# Wisconsin Department of Transportation

**Proposal #15: 2984-12-74, WISC 2024227**  
**C Milwaukee, N Holton St Phase 2**  
**Br Over Milw Rvr, Commerce, Water**  
**Local Street**  
**Milwaukee County**

This is Addendum No. 01, which provides for the following:

**ADDENDUM NO. 01**

Addendum No. 01  
 ID 2984-12-74  
 Revised Sheet 32  
 February 5, 2024

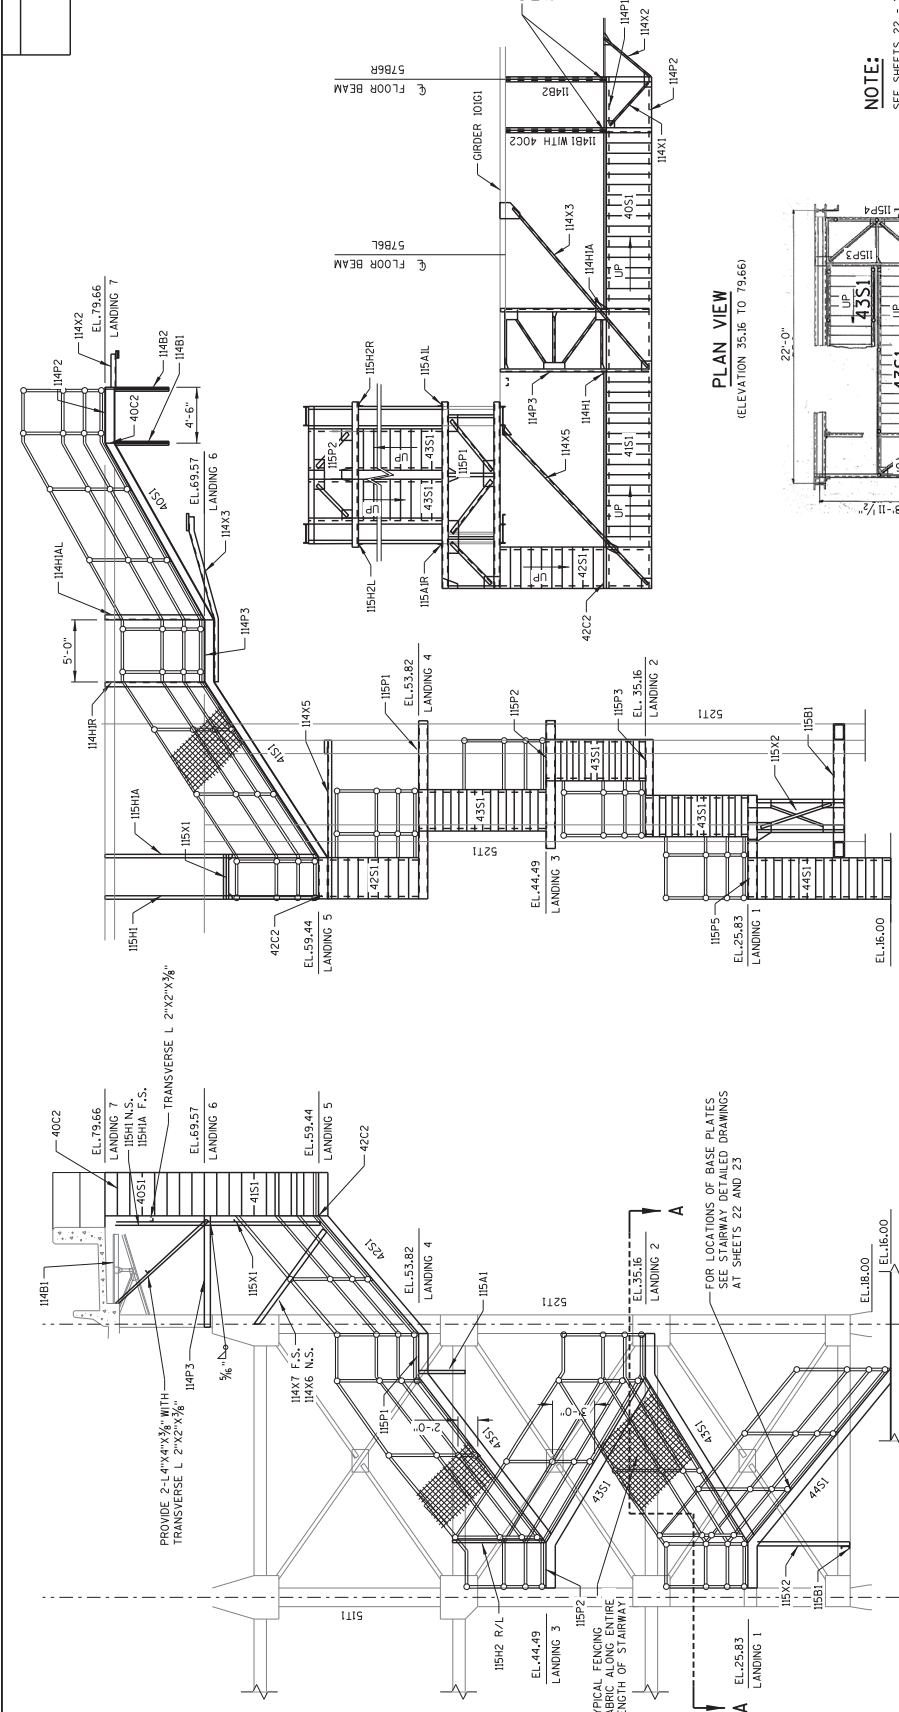
<b>Revised Plan Sheets</b>	
Plan Sheet	Plan Sheet Title (brief description of changes to sheet)
32	Estimate of Quantities (updated bid items)
48	Stair Tower Replacement (updated notes)
55	North and South Elevations Bent 9 (updated notes)
56	West and East Elevations Bent 9 (updated notes)
57	North and South Elevations Bent 10 (updated notes)
58	North and South Elevations Bent 11 (updated notes)
60	North and South Elevations Bent 12 (updated notes)
62	14 Member Details (updated notes)
63	15T2R/L Member Details (updated details)
67	47 Member Details (updated details)
69	49 Member Details (updated notes)
70	50 Member Details (updated details)
71	51 Member Details (updated notes)
72	52 Member Details (updated details)
86	15T2R/L, 47T1R E.&W. Elevation Member Details (updated details)
88	15T2L Member Details (updated details)
89	15T2R Member Details (updated details)
91	47T1LA Near Side Member Details (updated details)

Addendum No. 01  
ID 2984-12-74  
Revised Sheet 55  
February 5, 2024

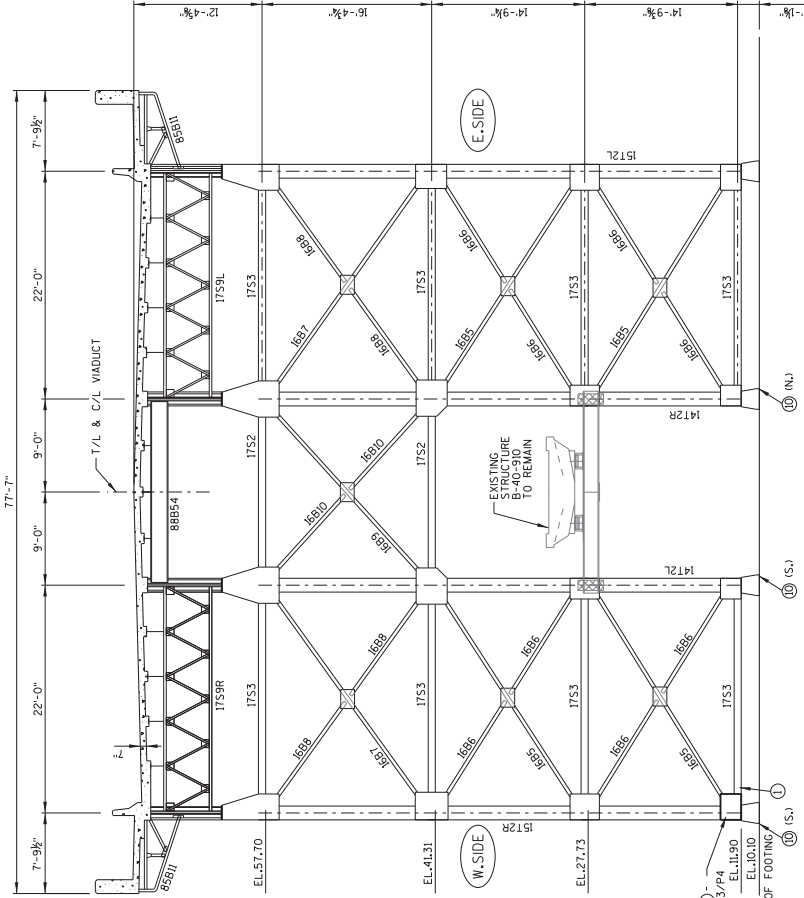
- 1 ADD FLANGE PLATE TO MEMBER 1522R. 1-OUTER 1'-0"X1/2"X4'-2" AT N. SEE SHTS. 36 AND 62.
- 2 ADD FLANGE PLATES TO MEMBER 1522R. 2-INNER & OUTER 5"X1/2"X9'-0" OVERALL LENGTH EACH LOCATION AT S.E. SEE SHTS. 36 AND 62, DETAILS 4 AND 5.
- 3 ADD FLANGE PLATE TO MEMBER 1522R. 1-INNER 5"X1/2"X15'-0" AT S.W. SEE SHTS. 36 AND 62.
- 4 REPLACE ANCHOR NUTS 1 1/2" AT AB4, AB4A, (N/S) NUT LOCATION. SEE SHTS. 35 AND 36.
- 5 XX REPLACE GUSSET PLATES (16P3, 16P4, 16P5, 16P6, 16P7, 16P8, AND 16P9) INNER AND/OR OUTER TO MEMBERS 1522R/L AND 16A7 MEMBERS (F.S./N.S.) SEE SHT. 36.
- 6 REPLACE GUSSET PLATE (16P2) INNER AND OUTER TO MEMBER 16B6/66. SEE SHT. 39.

Addendum No. 01  
ID 2984-12-74  
Revised Sheet 56  
February 5, 2024

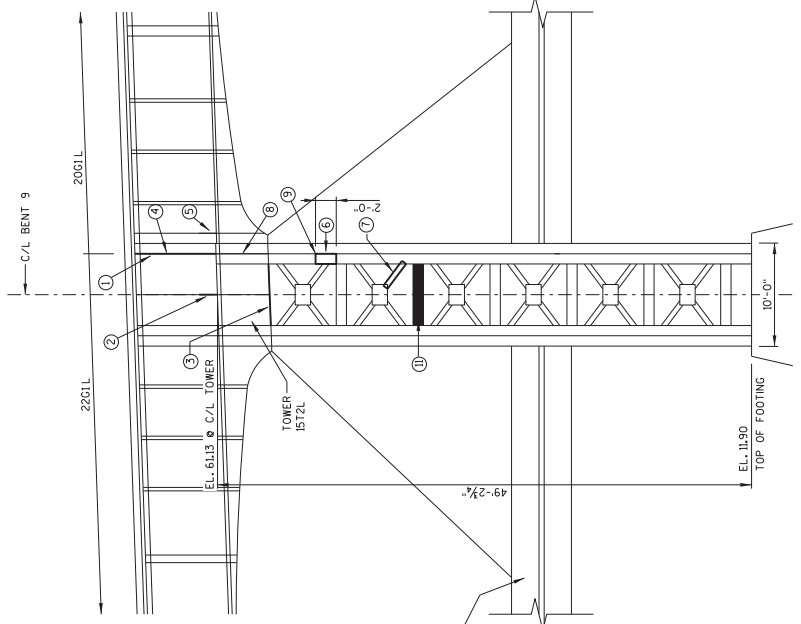
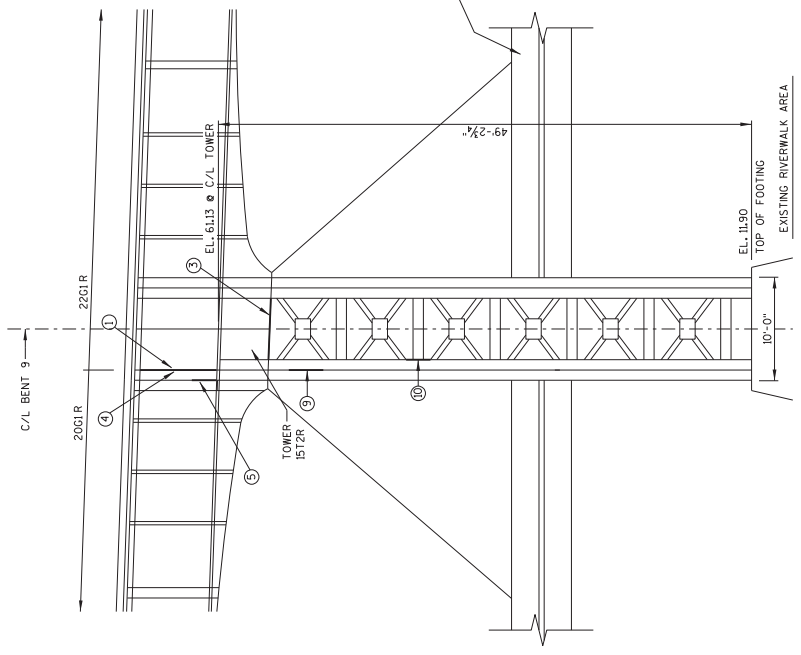
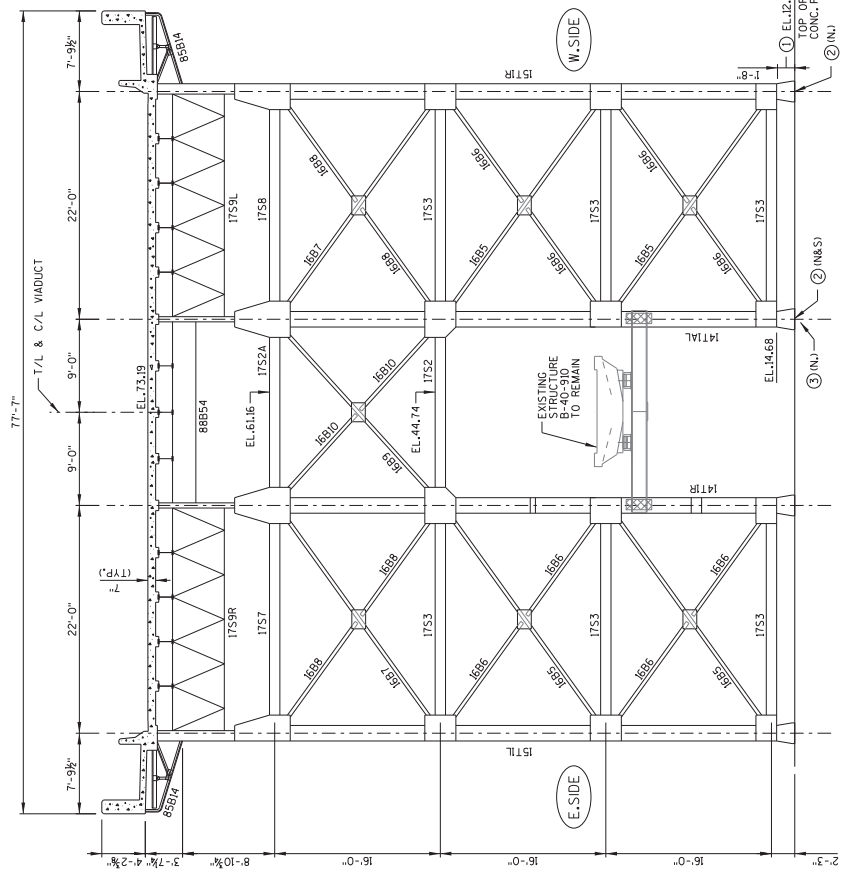
- ① REPLACE INNER STIFFENER (2251) TO MEMBER 2261R/L  
1-Z BAR 3/8"x5/16"x1/2" SEE SHT. 46.
- ② REPLACE LOWER 1'-2 1/2" OF EAST SIDE STIFFENERS TO MEMBER 2201L (INNER) 2252A, 2 TOTAL. SEE SHT. 46.

- ③ ADD BOT. FLANGE PLATE (5P10) TO MEMBER 1512R/L 2'-1'-0 1/2"x6'-0". SEE DETAIL 1 SHT. 36 AND 59.
- ④ REPLACE FULL HEIGHT STIFFENERS (205D) (INNER) 2'-L 1/2"x5 1/8"x1'-11 1/2" TO MEMBERS 2061R/L SEE SHT. 47.

- ⑤ REPLACE LOWER 1'-2 1/2" OF STIFFENERS (INNER) 2'-L 3/2"x5 1/8"x1'-2 1/2" TO MEMBERS 2061R/L SEE SHT. 47.
- ⑥ ADD WEB PLATES (2) TO 1512L (INNER AND OUTER) (5P1P 2'-8 1/2"x2'-0" TO EAST SIDE TOWER 1512L) PROVIDE FULL PLATES AT ADJACENT CROSS BRACE. SEE SHT. 36 AND 59.

- ⑦ REPLACE (1) - C6 90.5"x4'-6 1/2" AT TOWER 1512L SEE SHT. 36.
- ⑧ ADD PLATE (5P12) TO STIFFENER TO MEMBER 1512L 1'-5"x1/2"x4'-5 3/8". SEE SHT. 36 AND 59.

- ⑨ ADD FLANGE PLATES (5P14) TO MEMBERS 1512R/L 2'-6 1/2"x3'-0". SEE SHT. 36 AND 59.
- ⑩ ADD PLATE (5P13) TO SOUTH SIDE OF L3X3 OF MEMBER 1512R 1'-3"x1/2"x1'-6". SEE SHT. 36 AND 59.

- ⑪ REPLACE (1) C8 90.3-75"x1'-10" AND L3/2 X3/2 X 3/8 X5'-10 1/2" SEE SHT. 36.

Addendum No. 01  
ID 2984-12-74  
Revised Sheet 57  
February 5, 2024

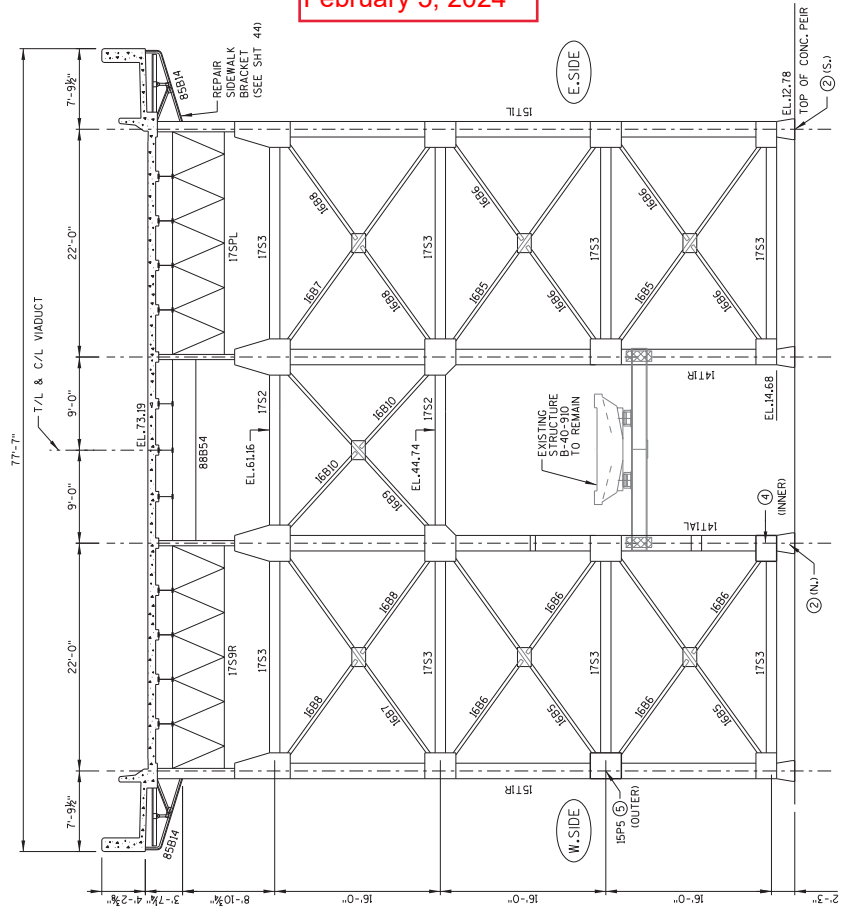
- 1 ADD (2) FLANGE PLATES TO MEMBER 15TR (INSIDE, OUTSIDE) S.E. 5'x1/2"x1'-8". SEE SHIT. 37 AND 60.
- 2 REPLACE ANCHOR NUTS 1 1/2" AT AB4, AB4A, IN/S, NUT LOCATION. SEE SHIT. 35 AND 37 FOR DETAILS.
- 3 ADD N. SIDE BASE PLATE, (14P3), SEE SHIT. 35 FOR DETAILS.
- 4 REPLACE CONNECTION ANGLES AND GUSSET PLATE (14P4) (INNER) TO MEMBER 14T1AL. SEE SHIT. 35 FOR DETAILS.
- 5 REPLACE GUSSET PLATE (16P5) (OUTER) TO MEMBER 15TR, 17S3, 16B5/16B6. SEE SHIT. 37 FOR DETAILS.

NORTH AND SOUTH ELEVATIONS  
BENT 11

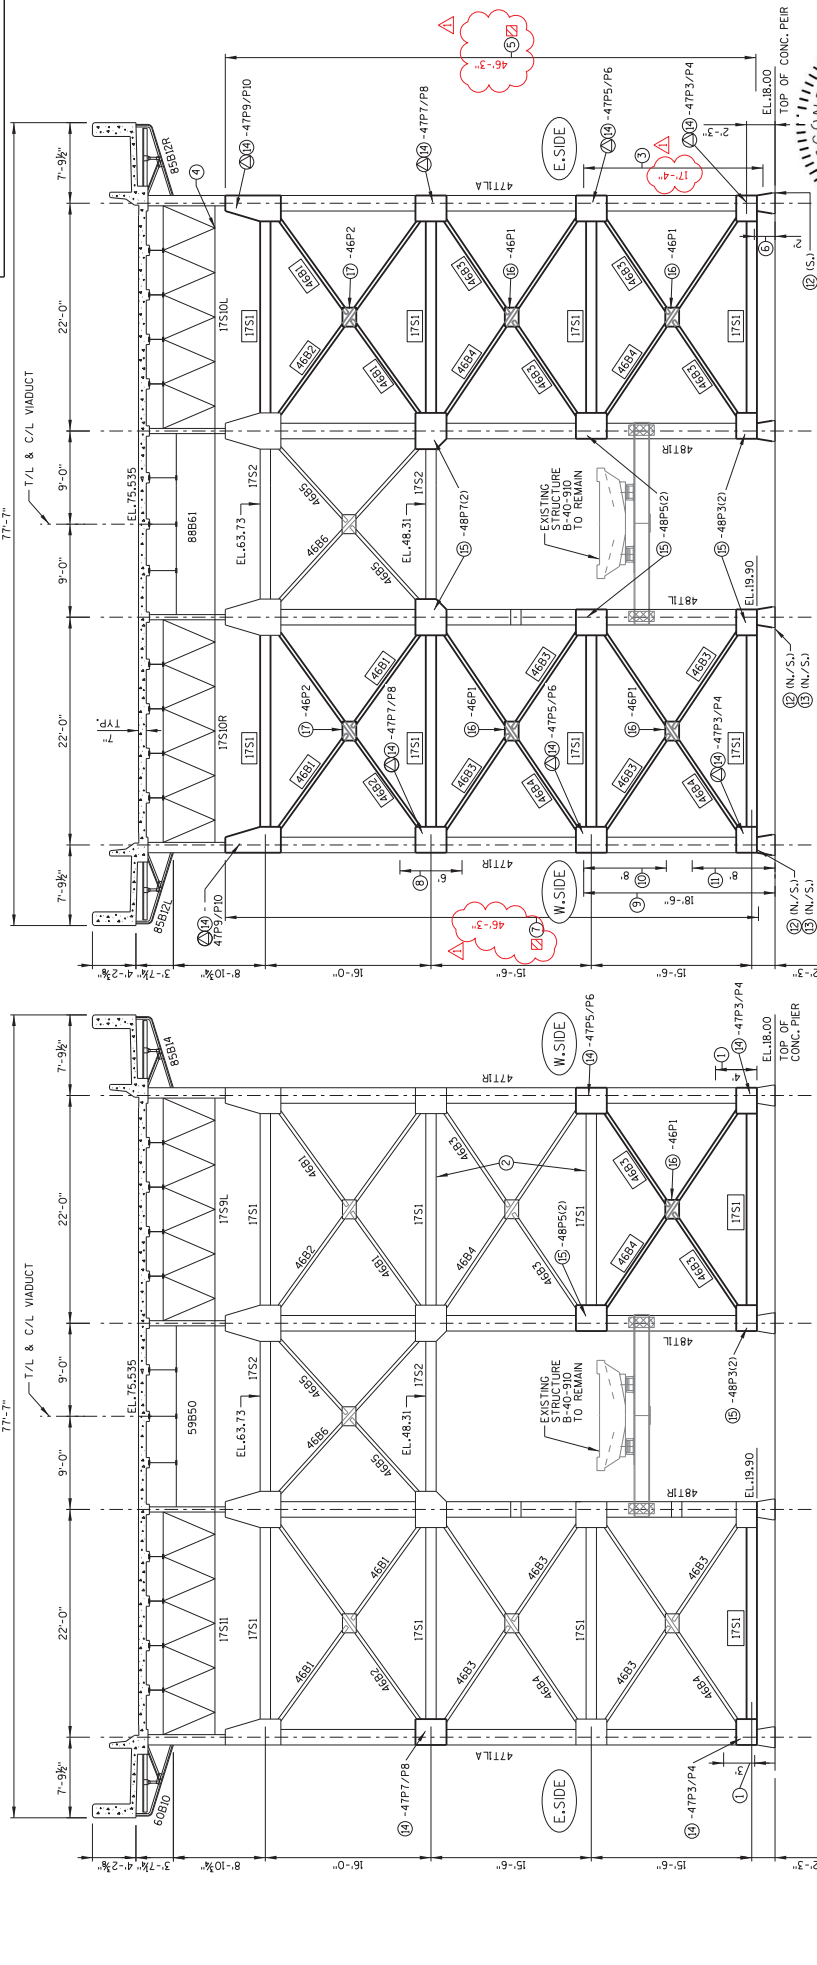
- XXXXX 1926 SHOP DRAWING NUMBER - REMOVE AND REPLACE PART
- XXXXX 1926 SHOP DRAWING PART NUMBER
- ① ADD FLANGE PLATE (INNER) TO S.W. FLANGE TO 477P3/P4. SEE SHTS. 40 AND 63.

- ② REPLACE ID TOTAL LACING BARS TO MEMBERS ITSIF.S. AT 2 LOCATIONS. SEE SHIT. 38.
- ③ ADD WEB PLATE (OUTER) TO MEMBER 477P3/P4. SEE SHTS. 40 AND 64.
- ④ REPLACE GUSSET PLATE (LOWER END) (7P3) TO MEMBER ITSOL. SEE SHIT. 38.

- ⑤ ADD FLANGE PLATES (INNER & OUTER) FULL HEIGHT TO S.W. AND N.W. AT MEMBER 477P3/P4. SEE SHTS. 40 AND 64.
- ⑥ ADD FLANGE PLATE (INNER) TO N.E. AT MEMBER 477P3/P4. SEE SHTS. 40 AND 64.

- ⑦ ADD FLANGE PLATE (OUTER) TO S.E. AT MEMBER 477P3/P4. SEE SHTS. 40 AND 64.
- ⑧ ADD FLANGE PLATE (INNER) TO S.W. AND N.E. AT MEMBER 477P3/P4. SEE SHTS. 40 AND 65.

- ⑨ ADD FLANGE PLATES (INNER) TO S.W. AND N.E. AT MEMBER 477P3/P4. SEE SHTS. 40 AND 65.
- ⑩ ADD FLANGE PLATE (OUTER) TO SOUTH FACE AT MEMBER 477P3/P4. SEE SHTS. 40 AND 65.

- ⑪ ADD FLANGE PLATE (INNER) TO N.W. TO MEMBER 477P3/P4. SEE SHTS. 40 AND 65.
- ⑫ ADD N.S. SIDE BASE PLATE (47P3, 48P3). SEE SHTS. 40 AND 41.

- ⑬ REPLACE ANCHOR NUTS 1/2" AT 46A, 46A4, (N.S. NUT LOCATIONS) SEE SHTS. 40 AND 41.
- ⑭ -XX- REPLACE GUSSET PLATES (47P3, 47P4, 47P5, 47P6, 47P7, 47P8, 47P9, 47P10) (INNER AND OUTER) TO MEMBERS 477P3/P4 AND 477P5/P6. (N.S./S.) SEE SHIT. 40.
- ⑮ -XX- REPLACE GUSSET PLATES (48P3, 48P4, 48P5, 48P6, 48P7) (INNER AND OUTER) TO MEMBERS 48T1R/L AND 48T1R/S. (N.S./S.) SEE SHIT. 41.
- ⑯ -XX- REPLACE GUSSET PLATES (46P3) (INNER AND OUTER) TO MEMBERS 46B3 AND 46B4. SEE SHIT. 45.
- ⑰ -XX- REPLACE GUSSET PLATES (46P2) (INNER AND OUTER) TO MEMBERS 46B1 AND 46B2. SEE SHIT. 45.

Addendum No. 01  
ID 2984-12-74  
Revised Sheet 58  
February 5, 2024

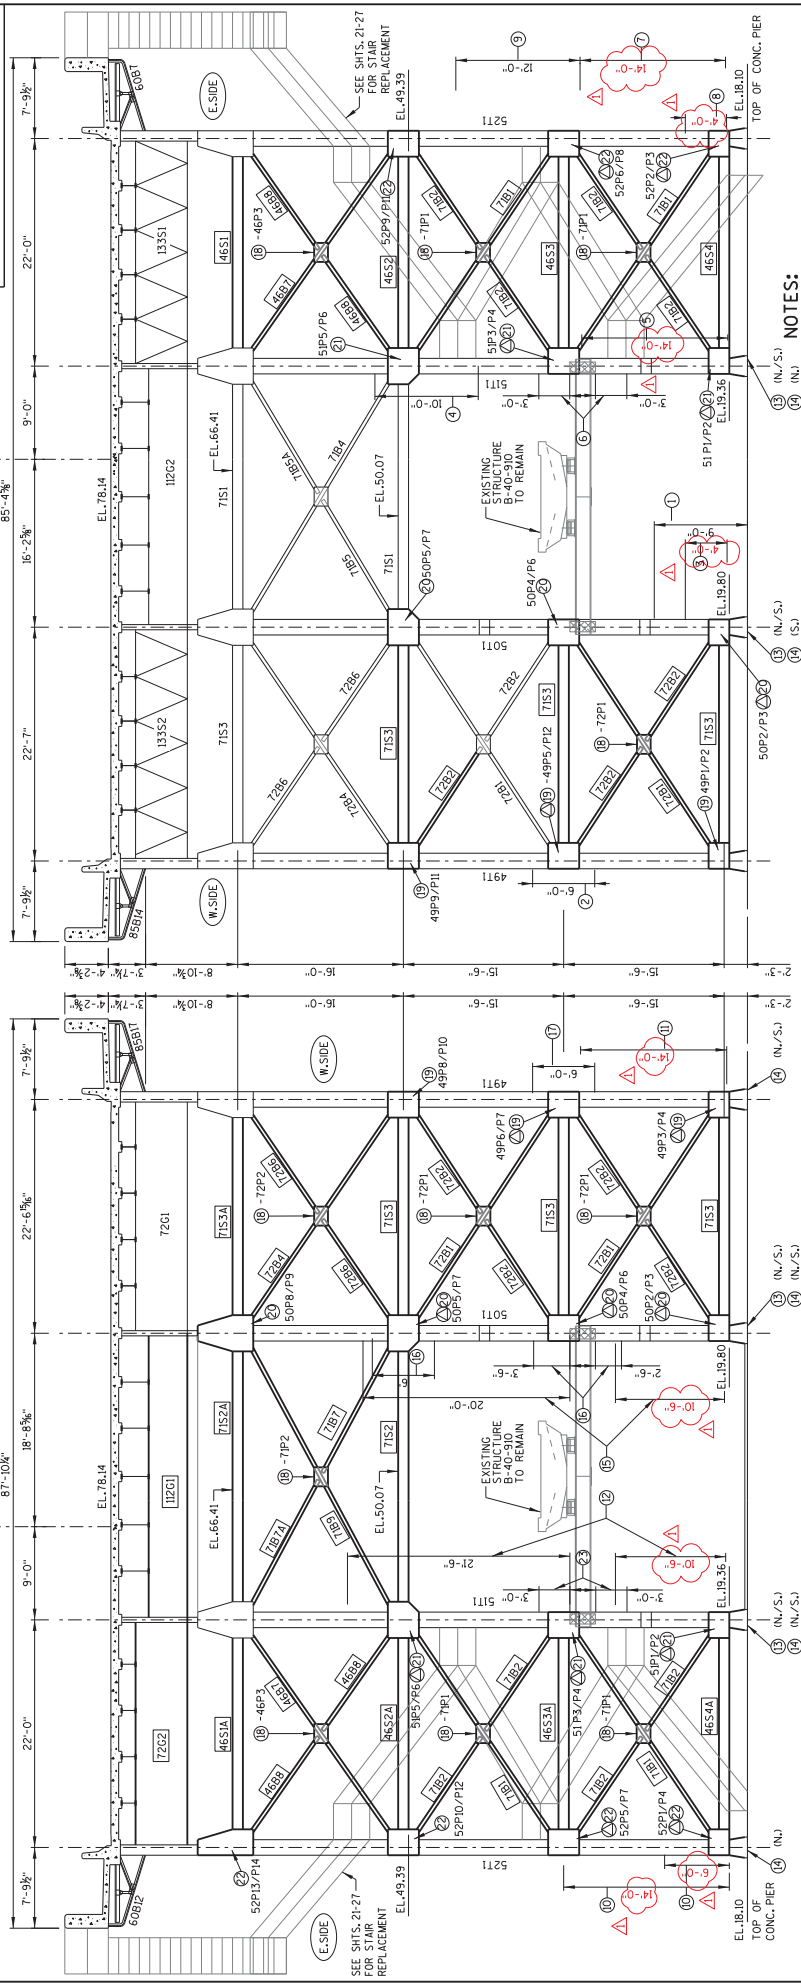
- XXXXX 1926 SHOP DRAWING PART REMOVE AND REPLACE PART
- 1 ADD FLANGE PLATE TO MEMBER 5011
- 1-INNER 5"x1/2"x14'-0" AT N.E./S.E. SEE SHTS 43 AND 68.
- 2 ADD FLANGE PLATE TO MEMBER 4911
- 1-OUTER 1'-0"x1/2"x14'-0" AT S.W. SEE SHTS 42 AND 66.
- 3 ADD FLANGE PLATES TO MEMBER 5011
- 1-OUTER 1'-0"x1/2"x14'-0" AT S.W. SEE SHTS 43 AND 68.
- 2-INNER 5"x1/2"x12'-0" AT N.W./S.W. SEE SHTS 45 AND 72.
- 4 ADD FLANGE PLATE TO MEMBER 5111
- 2-INNER 5"x1/2"x10'-0" AT N.E./S.E. SEE SHTS 44 AND 70.
- 5 ADD FLANGE PLATES TO MEMBER 5111
- 1-INNER 5"x1/2"x14'-0" AT N.E.
- 1-OUTER 5"x1/2"x14'-0" AT N.E. SEE SHTS 44 AND 70.
- 6 ADD FLANGE PLATES TO MEMBER 5111
- 2-INNER 5"x1/2"x13'-0" AT S.E.
- 1-OUTER 1'-0"x1/2"x14'-0" AT S.W. SEE SHTS 42-45.
- 7 ADD FLANGE PLATES TO MEMBER 5211
- 1-OUTER 1'-0"x1/2"x14'-0" AT S.W. SEE SHTS 42-45.

- 8 ADD FLANGE PLATES TO MEMBER 5211
- 2-INNER 5"x1/2"x14'-0" AT N.E./S.W.
- 1-OUTER 1'-0"x1/2"x14'-0" AT N.E./S.W. SEE SHTS 45 AND 72.
- 9 ADD FLANGE PLATES TO MEMBER 5211
- 2-INNER 5"x1/2"x12'-0" AT N.W./S.W. SEE SHTS 45 AND 72.
- 10 ADD FLANGE PLATES TO MEMBER 5211
- 1-OUTER 5"x1/2"x14'-0" AT S.W.
- 2-INNER 5"x1/2"x16'-0" (N.M. & N.E.) SEE SHTS 45 AND 71.
- 11 ADD FLANGE PLATE TO MEMBER 4911
- 1-OUTER 1'-0"x1/2"x14'-0" AT N. FACE. SEE SHTS 42 AND 66.
- 12 ADD FLANGE PLATES TO MEMBER 5111
- 1-INNER 5"x1/2"x10'-6" (S.W.)
- 1-OUTER 5"x1/2"x14'-0" AT N.E. SEE SHTS 44 AND 68.
- 13 ADD N/2S BASE SIDE PLATES (50P10, 51P7) SEE SHTS 43 AND 44.
- 14 REPLACE ANCHOR NUTS 1 1/2" AT A84, A84A, A84B. REPLACE ANCHOR NUTS SEE SHTS 42-45.

- 15 ADD FLANGE PLATES TO MEMBER 5011
- 2-OUTER 1'-0"x1/2"x10'-6" AT S.W.
- 4-INNER 5"x1/2"x14'-0" AT N.E./S.W. & S.W.
- 1-INNER 5"x1/2"x10'-0" AT N.E./S.W. SEE SHTS 43 AND 67.
- 16 ADD WEB PLATES TO MEMBER 5011
- 1-5"x1/2"x2'-6" AT WEST (INSIDE FACE)
- 1-5"x1/2"x2'-0" AT WEST (INSIDE FACE)
- 3 LOCATIONS. SEE SHTS 43 AND 67.
- 17 ADD FLANGE PLATE TO MEMBER 4911
- 1-INNER 5"x1/2"x6'-0" AT (W) SEE SHTS 42 AND 66.
- 18 XX REPLACE GUSSET PLATES (46P3, 71P1, 71P2, 72P1, 72P2, 71B1/B2/B7/ B7A/B9 AND 72B4/B6. SEE SHTS 49-51.
- 19 XX REPLACE AND/OR REINSTALL EXISTING GUSSET PLATES (49P1, 49P2, 49P3, 49P4, 49P5, 49P6, 49P7, 49P8, 49P9, 49P10, 49P11, 49P12, INNER AND/OR OUTER) TO MEMBERS 4911 (N.S./F.S.). SEE SHIT 42.
- 20 XX REPLACE CONNECTION ANGLES AND/OR REINSTALL EXISTING GUSSET PLATES (50P4/P9, 50P5/P10, 50P6/P11 AND/OR OTHER) TO MEMBERS 5011 (N.S./F.S.) SEE SHIT 43.
